**CHARTER TOWNSHIP
OF YPSILANTI
PLANNING COMMISSION**

Staff Report
Range USA
660 James L. Hart Parkway
Preliminary Site Plan Review

**Site Plan Review
For
Ypsilanti Township, Michigan**

RE: Shoot Point Blank
660 James L. Hart Parkway
Site Plan Review #2

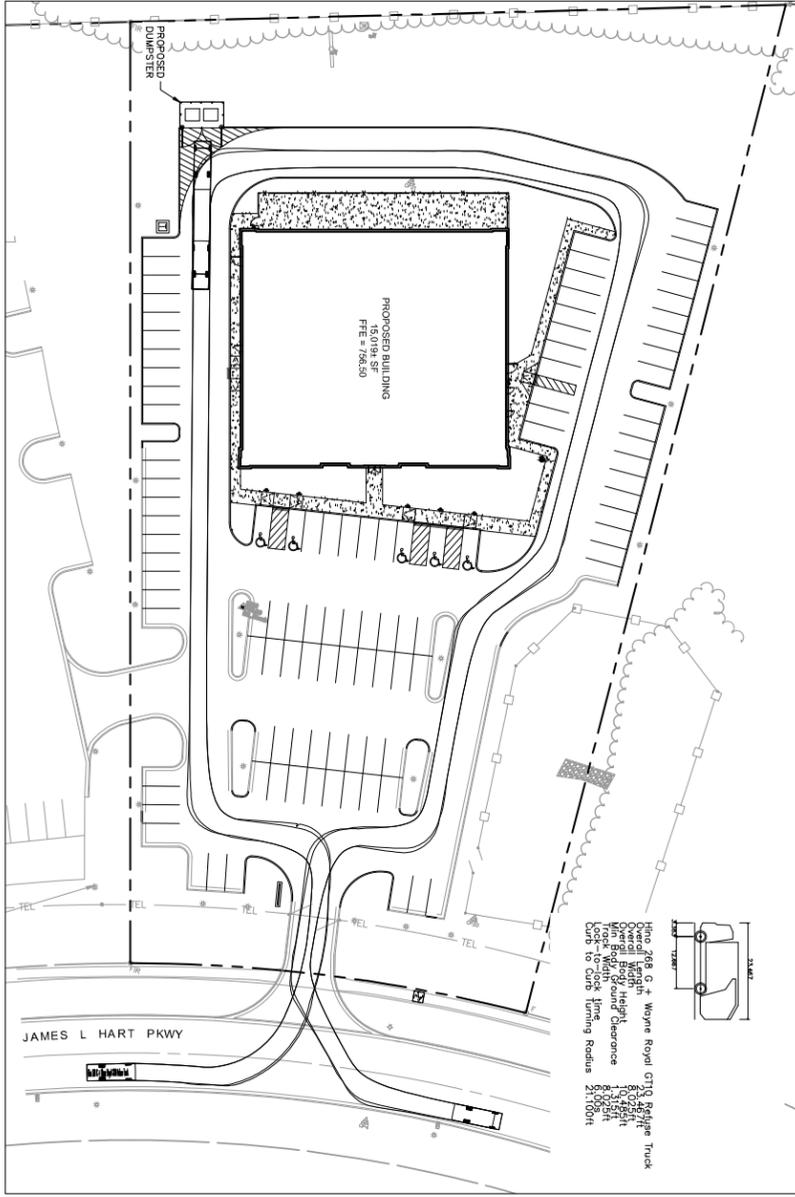
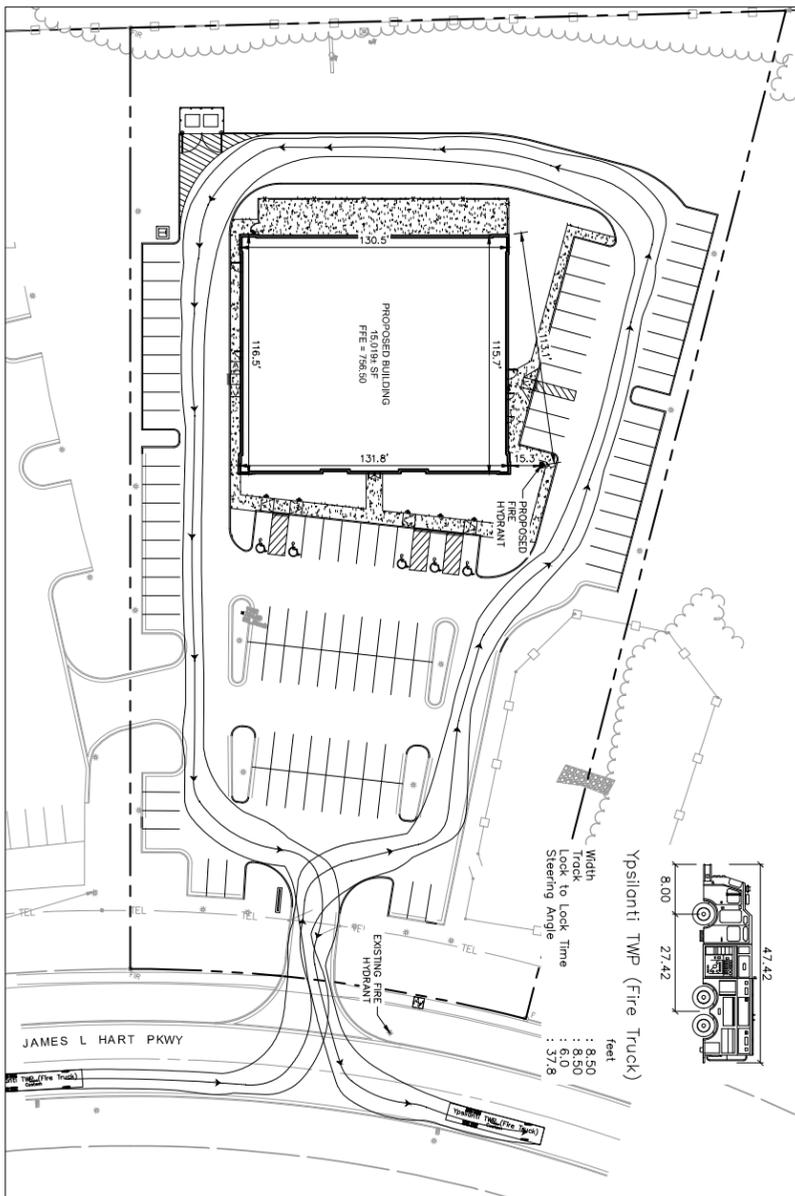
The site will be accessed via one (1) access on James L Parkway and one (1) shared access to the south (Bank Supplies) parcel. A fire truck turning template was submitted on Sheet C.3.1. The turning template should be reviewed by the Fire Marshall.

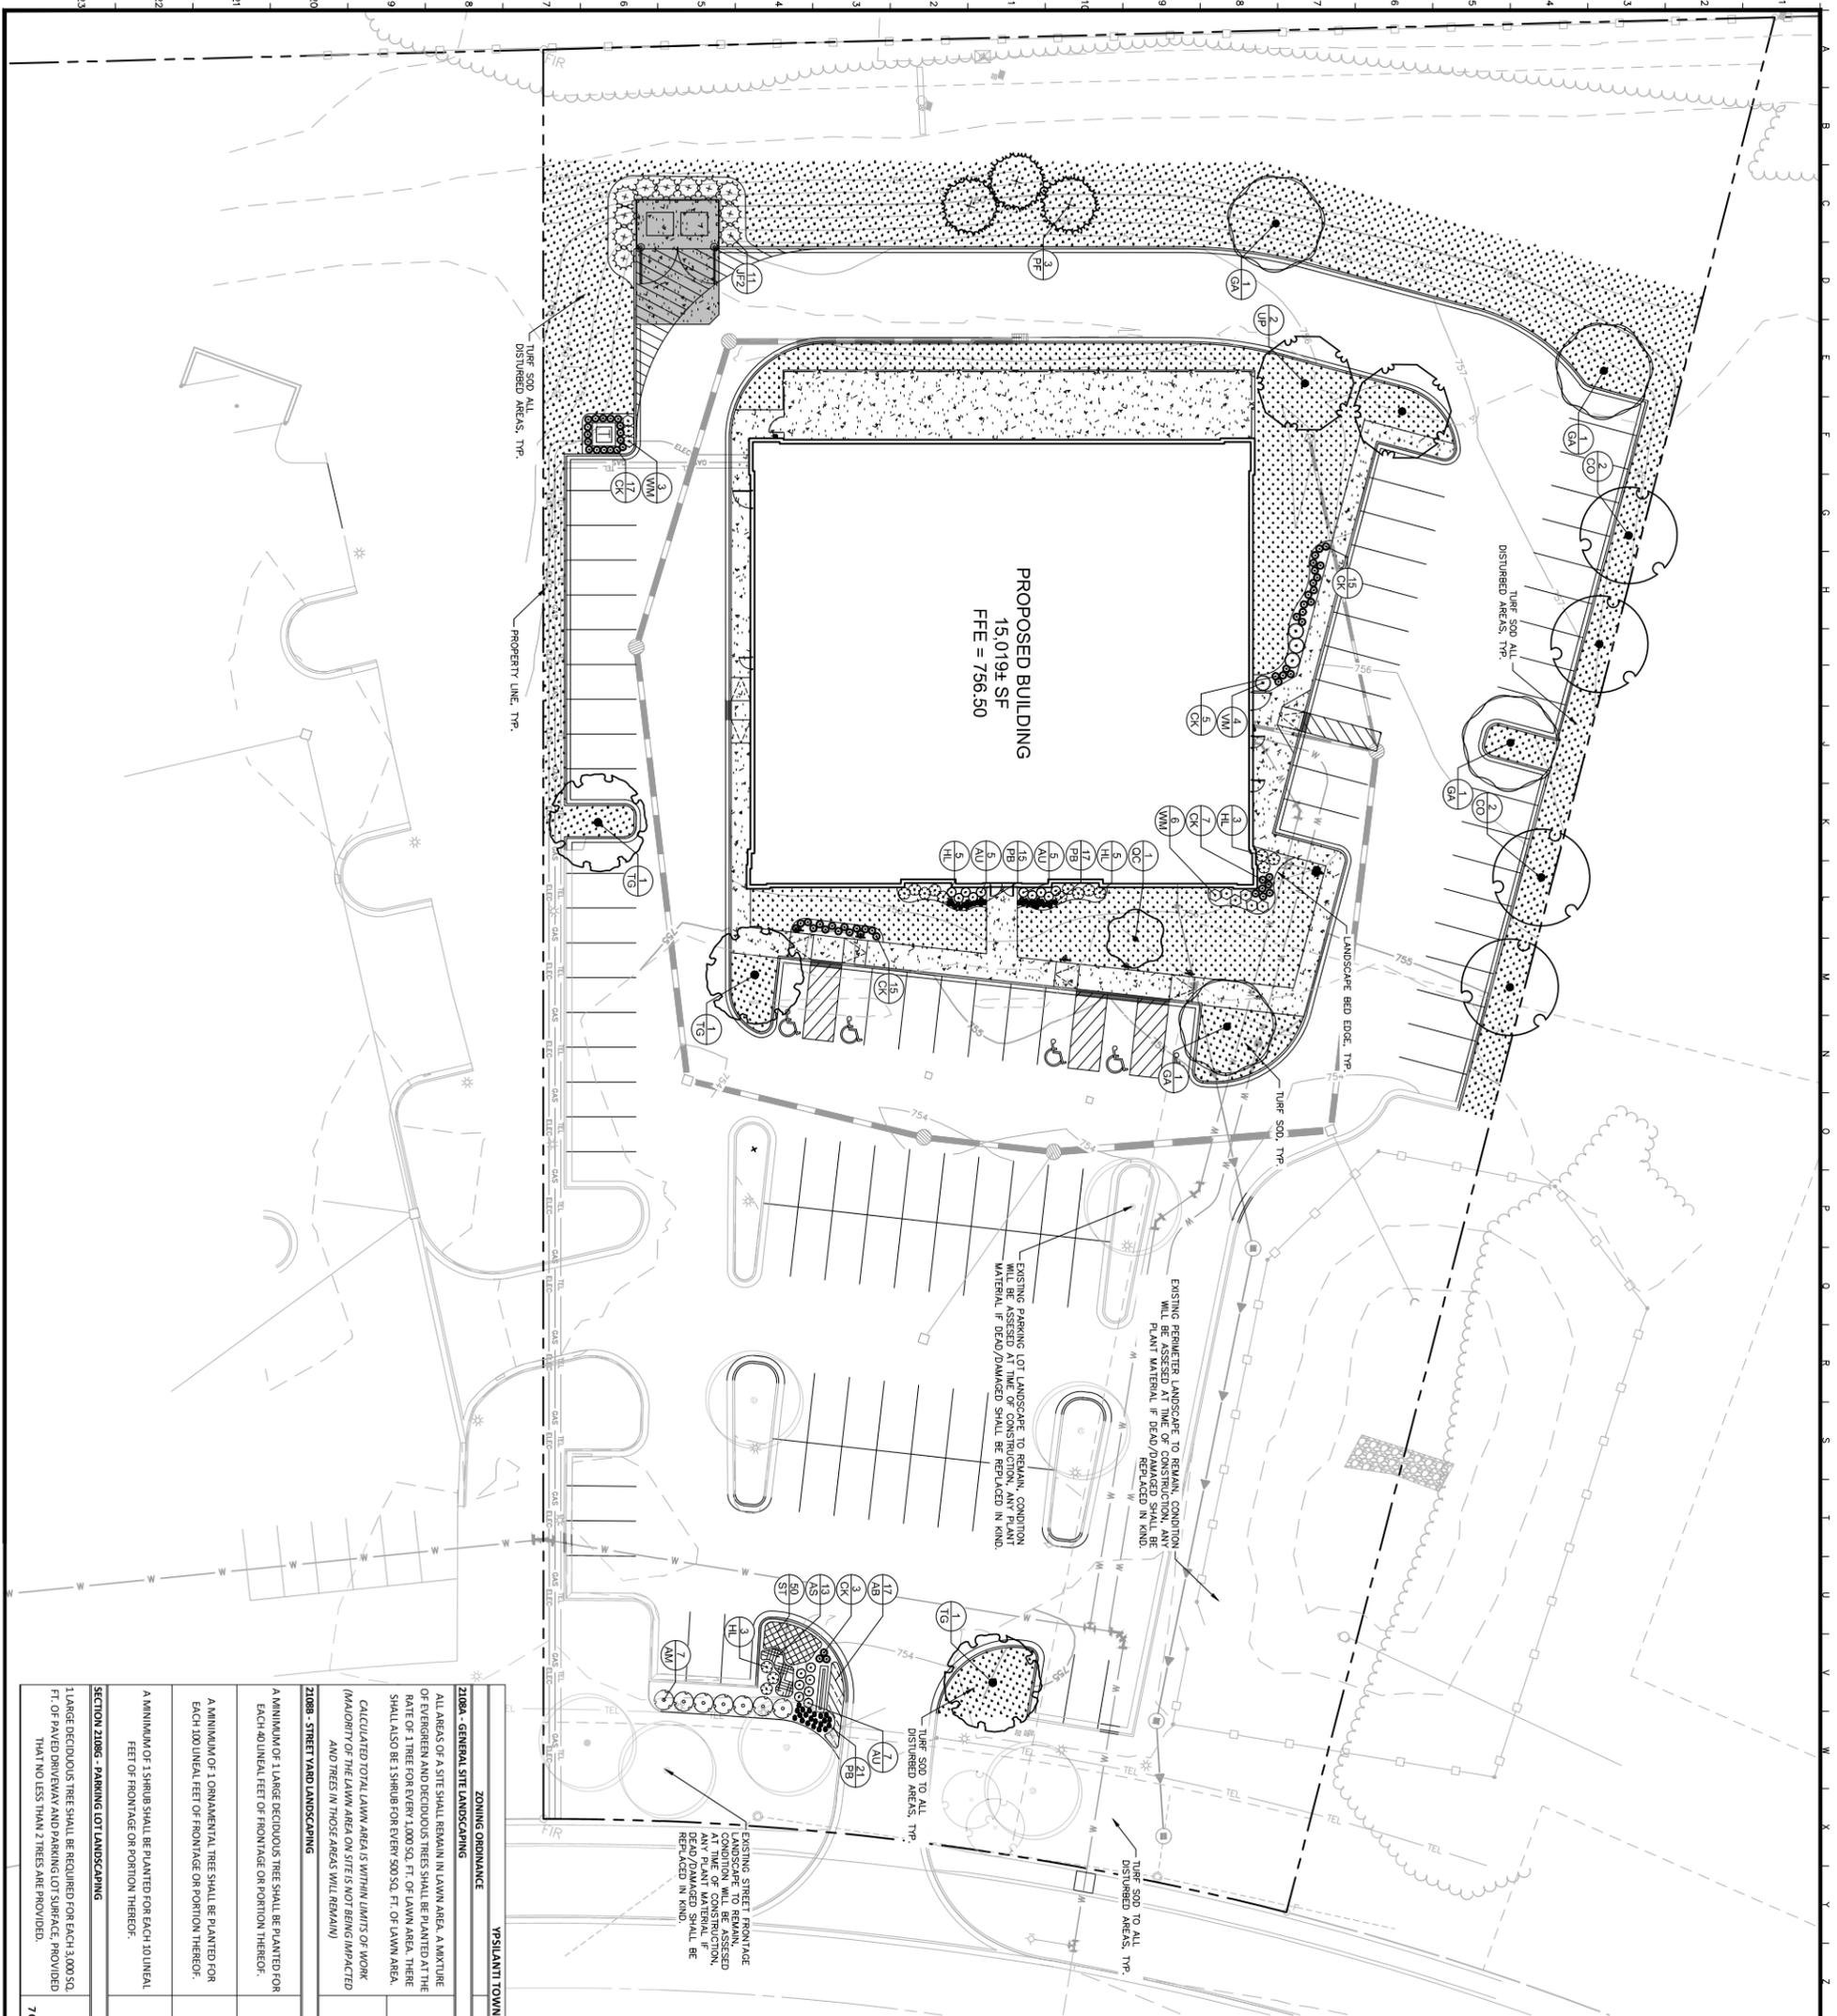
A landscape plan has been provided as part of the site plan submittal. The landscape plan was not sealed by a registered landscape architect. The applicant notes that the landscape plan will be sealed as condition of final site plan.

Items to be Addressed: Seal Landscape Plan by a licensed landscape architect for final site plan

1. *Stamp Landscape Plan by licensed landscape architect*
